**REDEVELOPMENT OF AN EXISTING DERELICT HOTEL AT TA' KALANKA,
DELIMARA**

ENVIRONMENTAL PLANNING STATEMENT: ADDENDUM

Comments on the 1st draft of the Environmental Planning Statement (EPS)

PA 02767/16 (EA 7/16): Redevelopment of an existing derelict hotel including environmentally friendly measures and provision of public ancillary facilities at Ta' Kalanka, Delimara.

Figure 3.12: Proposed Plan Level 0

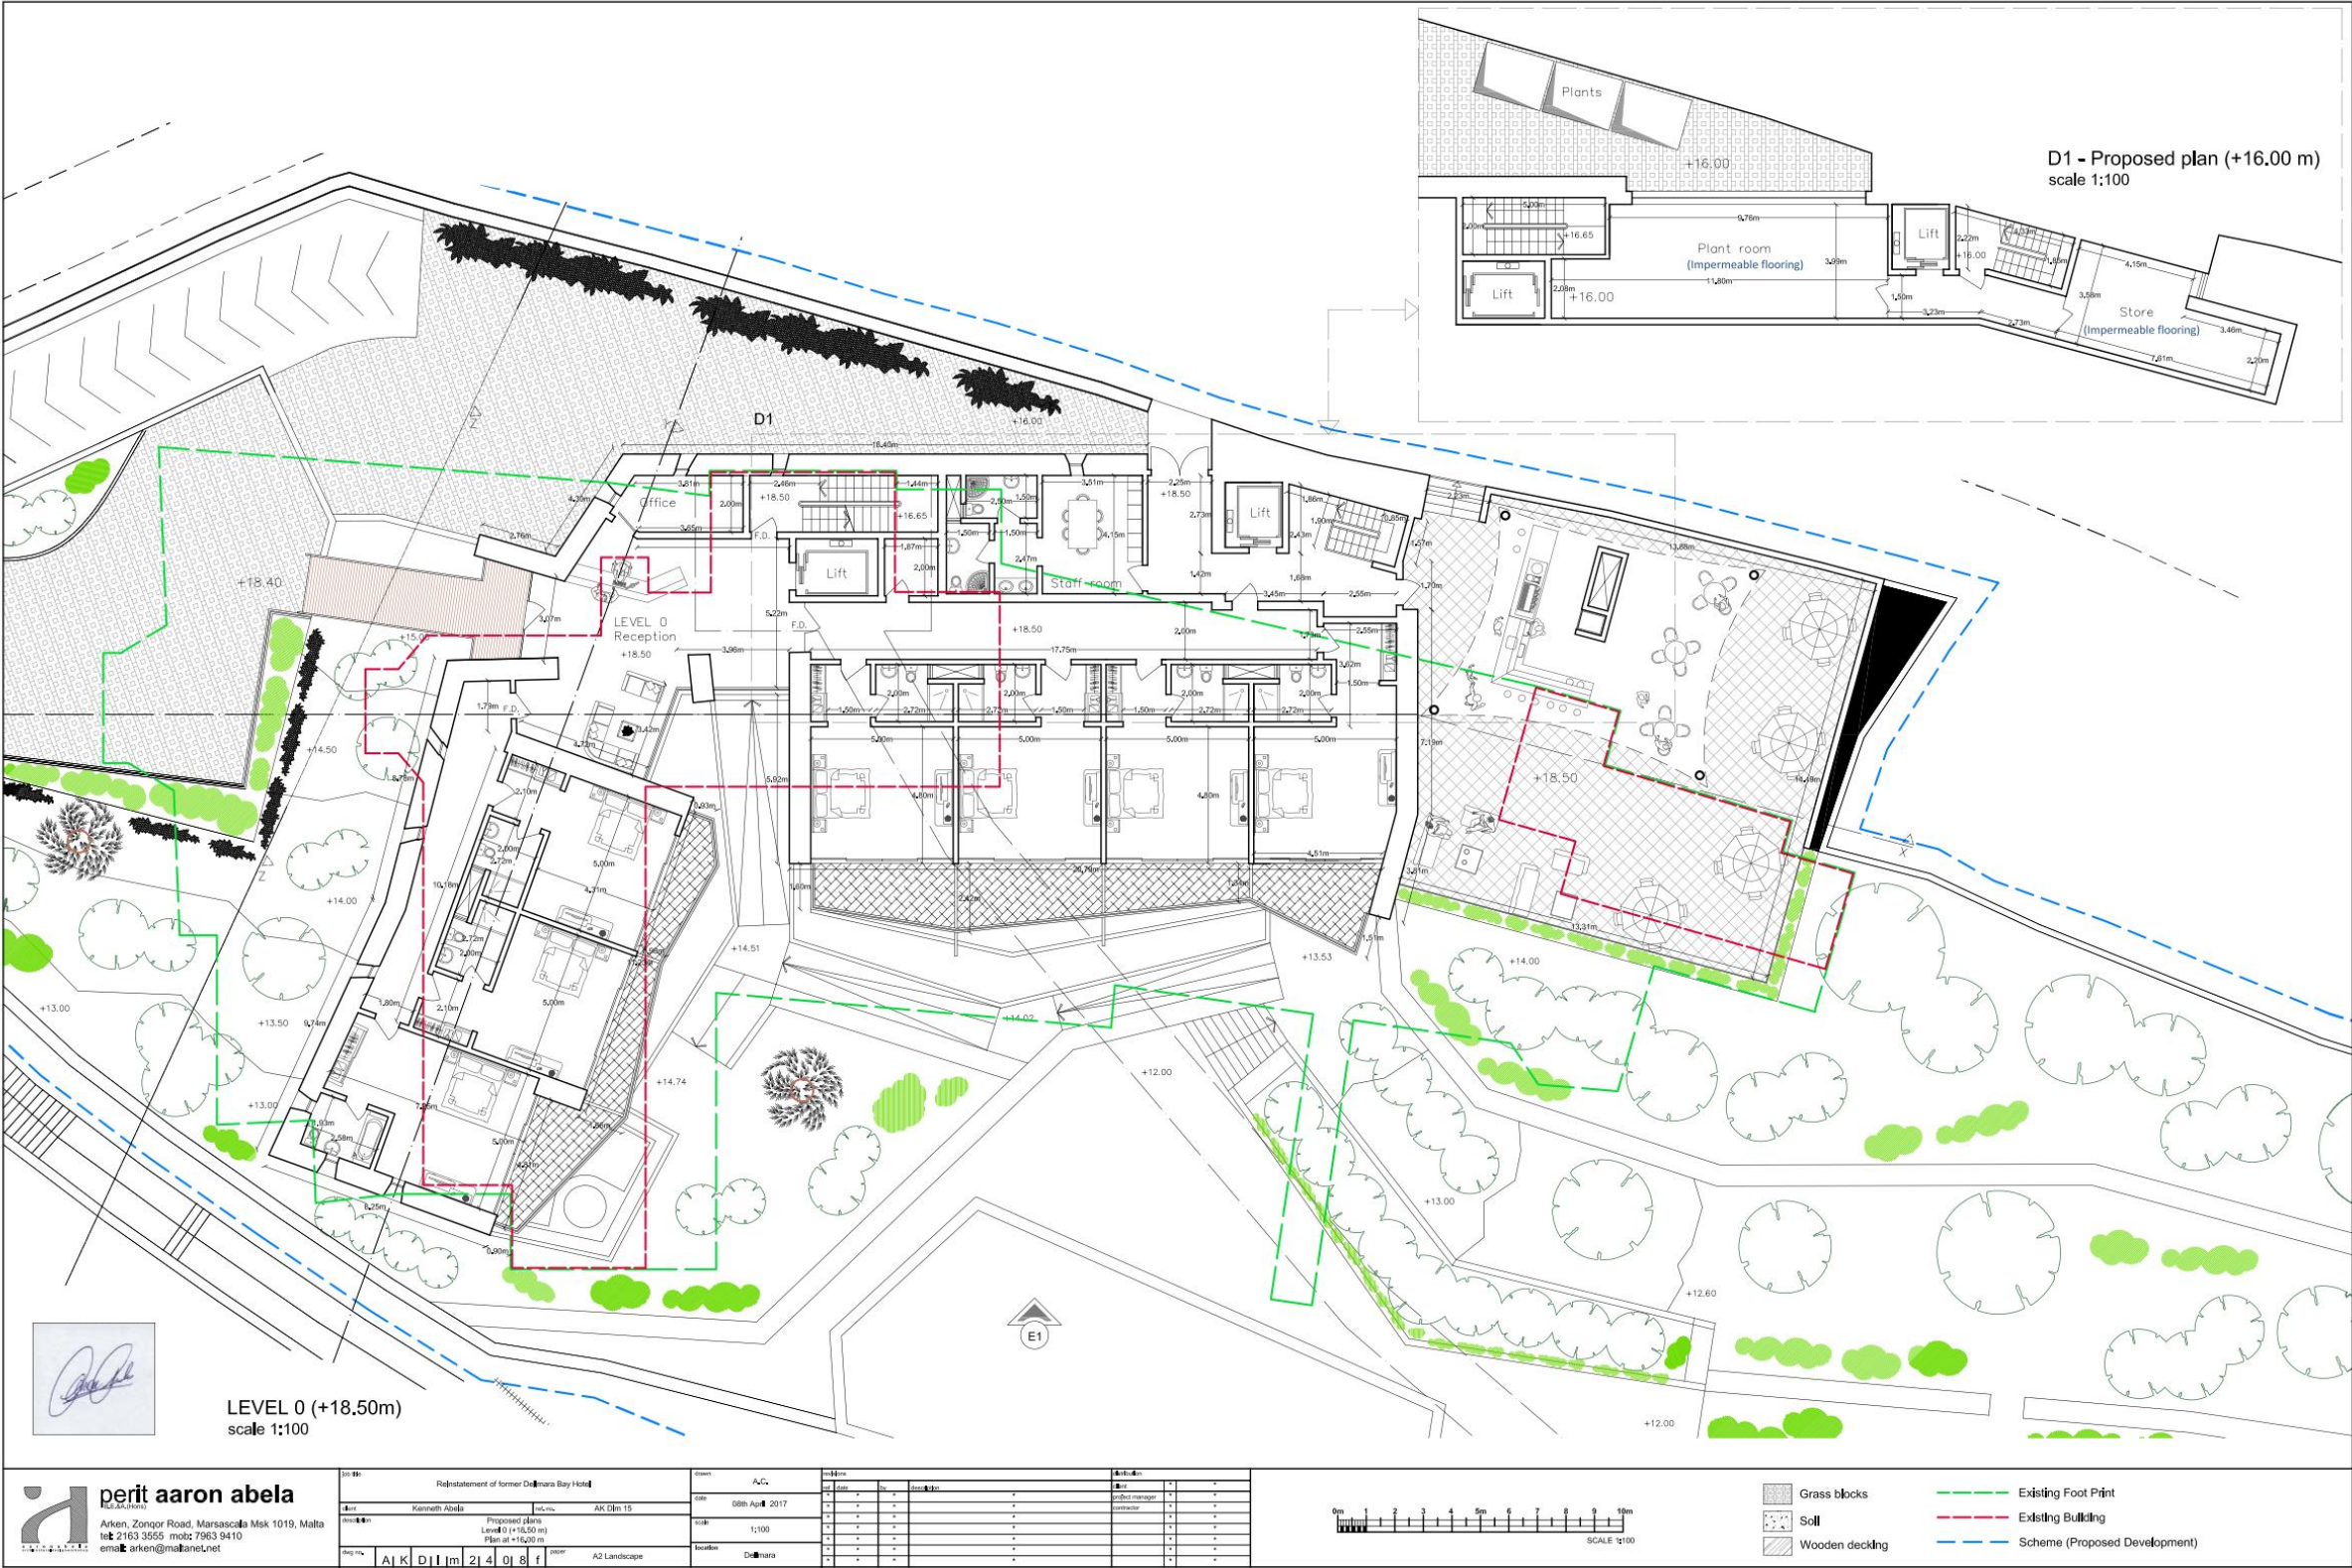
12	49	3.5 8	The EPS is to include plans of all room/area/store with impermeable flooring to cater for wastes to be stored, while pending collection for the operational phases.	See Appendix 1 of this Addendum (updated Figure 3.12). Note that this information is typically addressed in the environmental permit application.	Figure 3.12 in Appendix 1 is being noted, however kindly indicate the location of the waste room/area/store on plans.	Refer to updated Figure 3.12 of this Addendum where impermeable flooring has been marked. This is intended as a waste storage area.	Noted.
13	49	3.5 8	The frequency of disposal of waste is to be included in the EPS, along with their respective storage e.g. bins, drums, skips, etc. within the designated area (proposed waste room).	This information is not considered to inform the EIA and will be addressed in the environmental permit application.	Referring to comment 12, the respective storage is to be shown on plans and identified as waste room/area/store.	As above.	As above.

CESSPIT SECTION

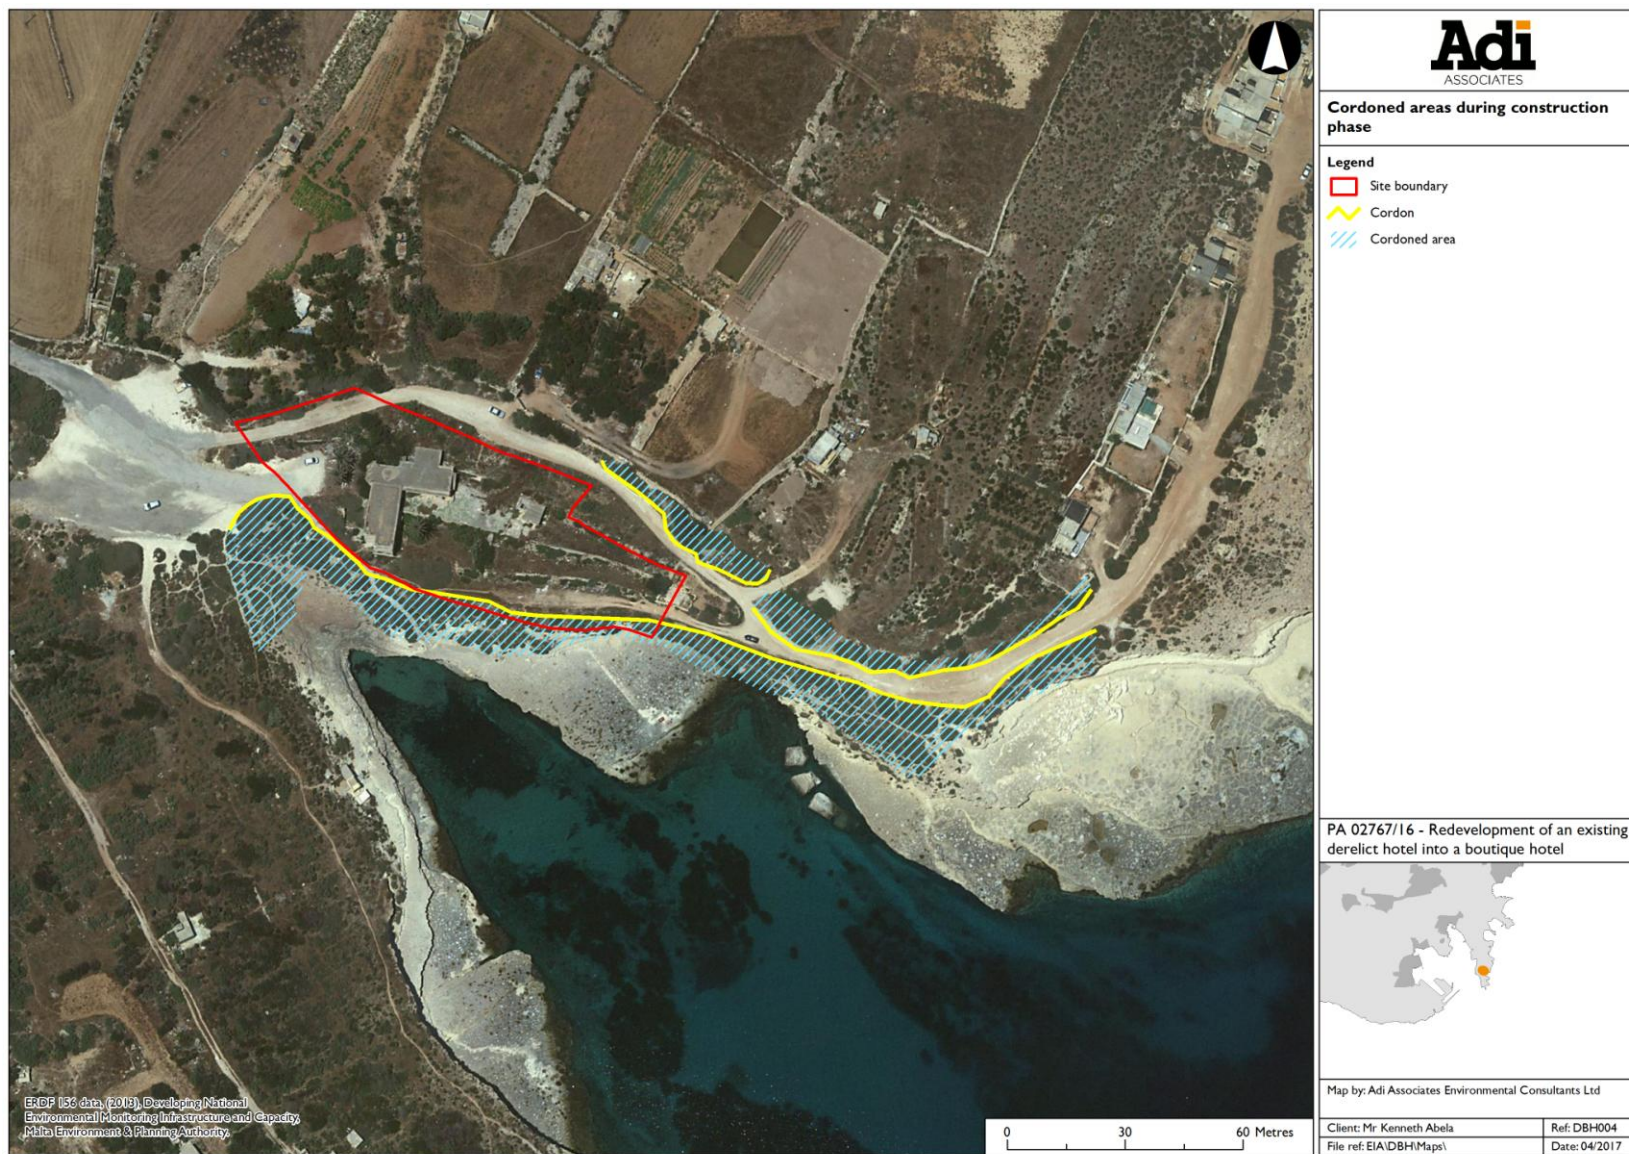
<p>site; and</p> <p>v. The method of transportation and frequency.</p> <p>This information should be presented in table format, as already provided for the construction phase in the EPS p 46.</p>				
15	50	3.6 4	<p>Kindly indicate how the beach facilities will be connected to the cesspit. Details regarding any work interventions, including construction works across the beach required to connect the beach facilities to the main cesspit are required.</p>	<p>The sewage collected at beach level will be pumped up to the main cesspit (located at a higher level to the facilities, refer to Figure 3.15). Thus, the connection from the beach facilities and the main cesspit will be through the proposed tunnel and lift shafts.</p>	<p>Kindly provide an updated cross-section for the cesspit showing how it is appropriately ventilated so as to avoid the accumulation of explosive, toxic or corrosive gases.</p>	<p>Appendix 4 to this Addendum has been updated to reflect this.</p>	<p>Noted..</p>

Figure 9.2: Noise sensitive receptors

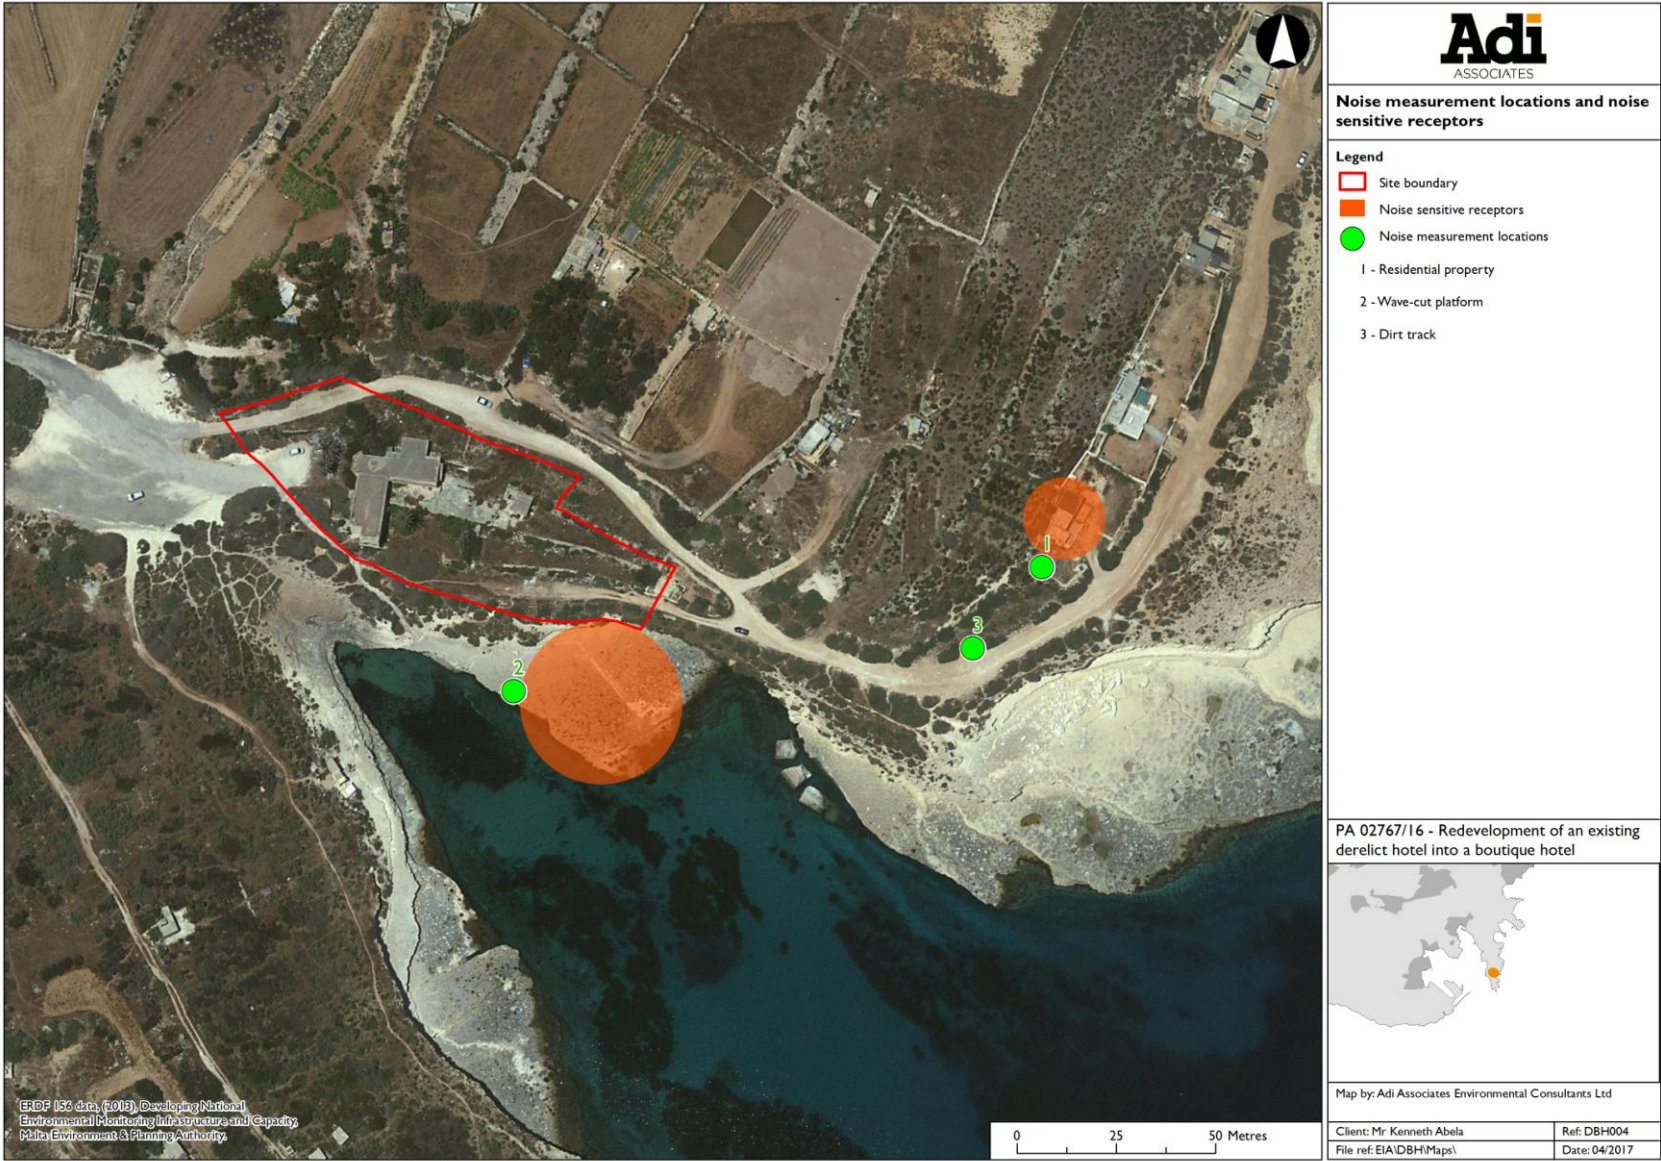
42	188	Table 9.5	<p>Kindly explain why, as for the operational phase, the estimated sound levels are reflected on the sensitive receptors (118 m from noise source), while for the construction phase these are reflected on the sensitive residential receptors (95 m from source) and recreational receptors (adjacent to source).</p> <p>It is envisaged that recreational receptors adjacent to the source, are present both during the construction and operational phase. In what manner these shall be impacted?</p>	<p>The estimated sound levels for operational noise (chatter, general activity and amplified music on the terrace of the restaurant) at the nearest residential sensitive receptors assume the closest of this activity to be at the eastern edge of the terrace, which is a distance of approximately 118 m from the nearest residential receptor. The estimated sound levels for construction noise at the nearest residential sensitive receptors assume the closest construction activity to be on the eastern perimeter of the site (the site boundary), a distance of approximately 95 m from the nearest residential receptor.</p> <p>The impact of construction noise on the recreational sensitive receptors is explained in paragraphs 9.56 – 9.58 of the EPS. Regarding operational noise impacts, the scoping assessment identified the most critical potential noise impacts arising from the operation of the Scheme to be on the residential sensitive receptors in the evening time, from the use of the outdoor terrace. From observation, the recreational sensitive receptors primarily use the beach during the day time. The scoping exercise concluded that those</p>	Noted. No further comments.	Noted.	-
